414-S843

SERVICE**TECHNICAL BULLETIN**

Battery Quiescent Drain –
Wipers In Intermittent –
Service Action S843

MODEL 2001-02 MY
XK Range

ILLUSTRATION 1

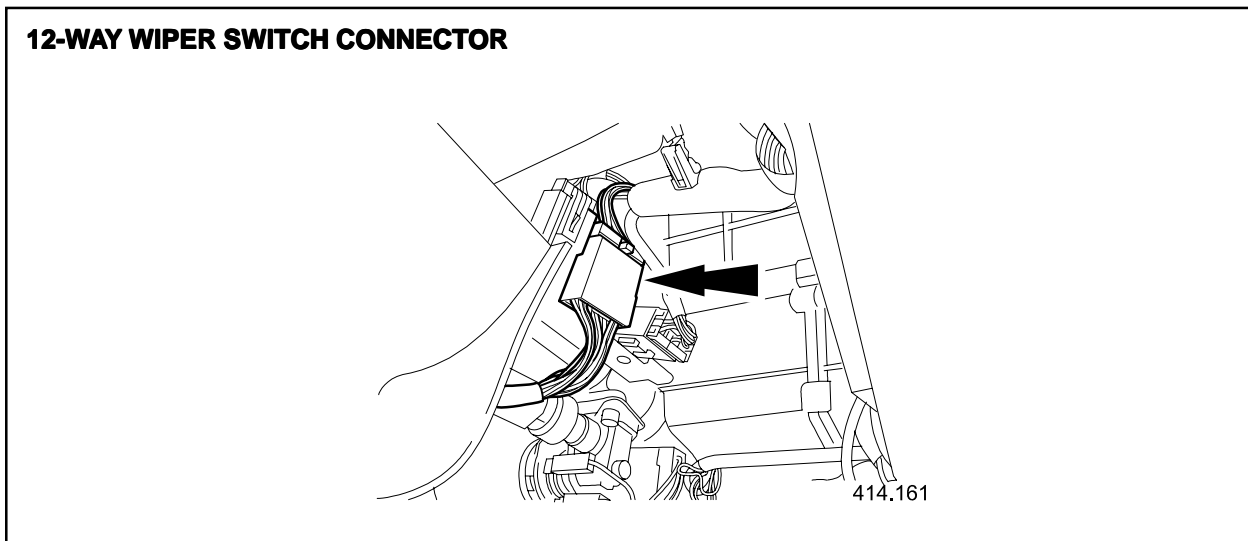
3. Displace white 12-way wiper switch connector from the retaining tang on the right hand side of the steering column, Illustration 1.

ILLUSTRATION 2

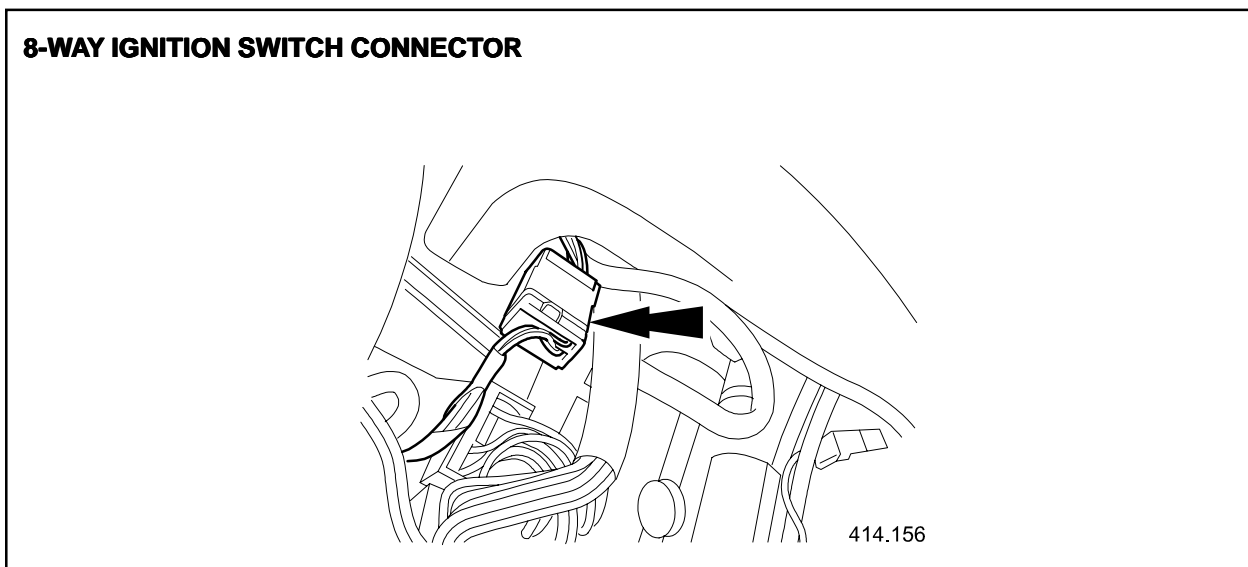
4. Disconnect the white 12-way wiper switch electrical connector.
5. Displace the anti-back-out device from the harness side connector.
6. Displace pin 9 (black).
7. Displace the white eight-way ignition switch connector from the retaining tang on the left hand side of the steering column, Illustration 2

ILLUSTRATION 3

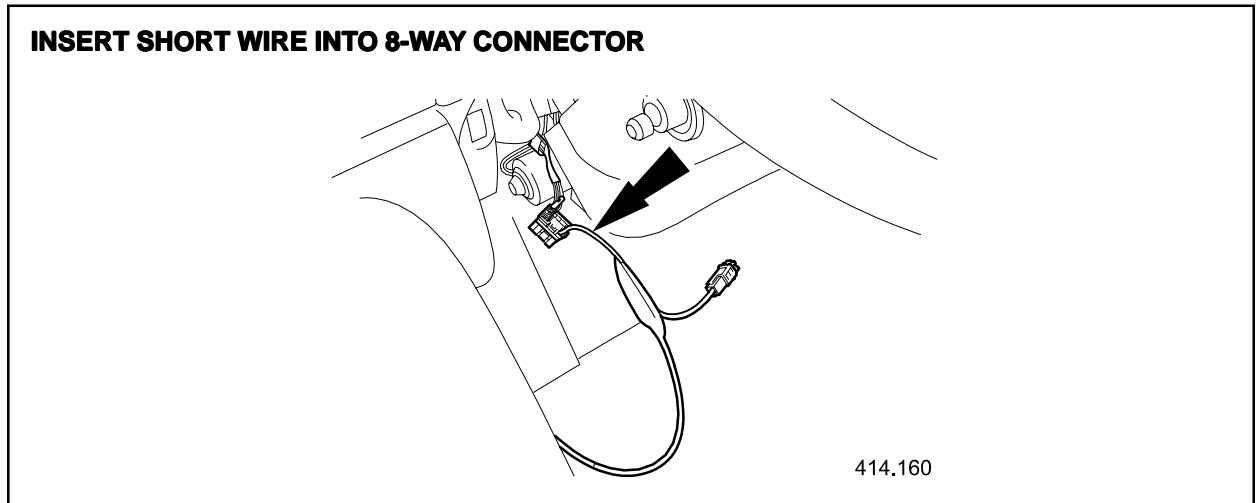
11. Place the new link lead to front.
12. Wrap the Part Number label for the new link lead around the lead and secure using suitable tape.
13. Insert the shortest wire from the link lead into the vacated cavity 3 in the eight-way connector (Illustration 3).

ILLUSTRATION 4

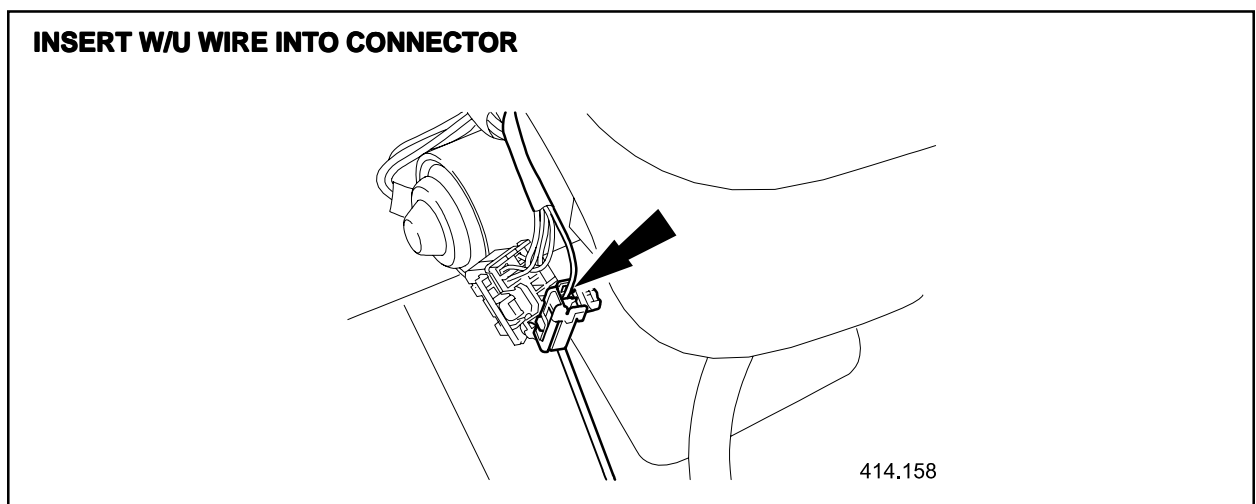
14. Close anti-back-out device of the eight-way connector.
15. Reconnect the eight-way connector.
16. Remove the male two-way connector from the link lead.
17. Displace the anti-back-out device.
18. Insert the white/blue wire previously removed from the eight-way connector pin 3 into the two-way connector (Illustration 4).

Note: Ensure the white/blue wire is installed into the correct cavity to line up with the wire in the link lead.

ILLUSTRATION 5

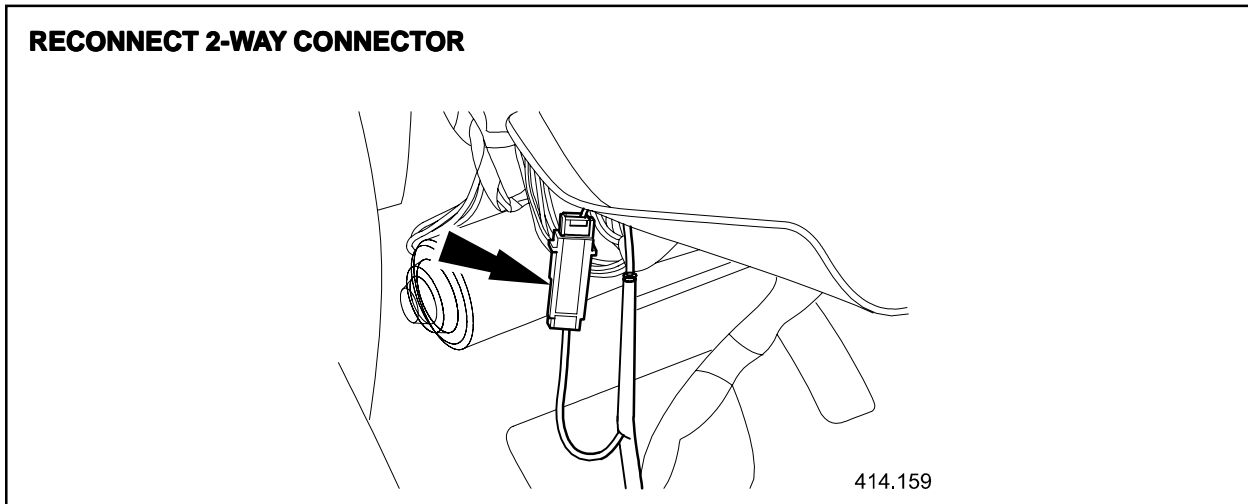
19. Close the anti-back-out device.
20. Reconnect the two-way connector (Illustration 5).

ILLUSTRATION 6

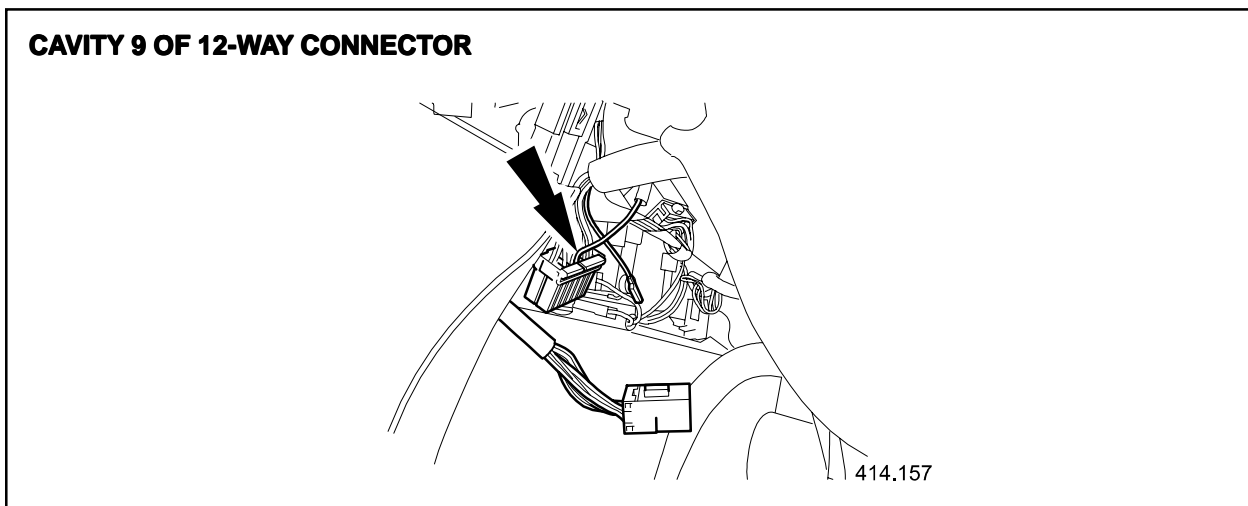
24. Insert the remaining pin from the link lead into vacated cavity 9 of the 12-way connector (Illustration 6).
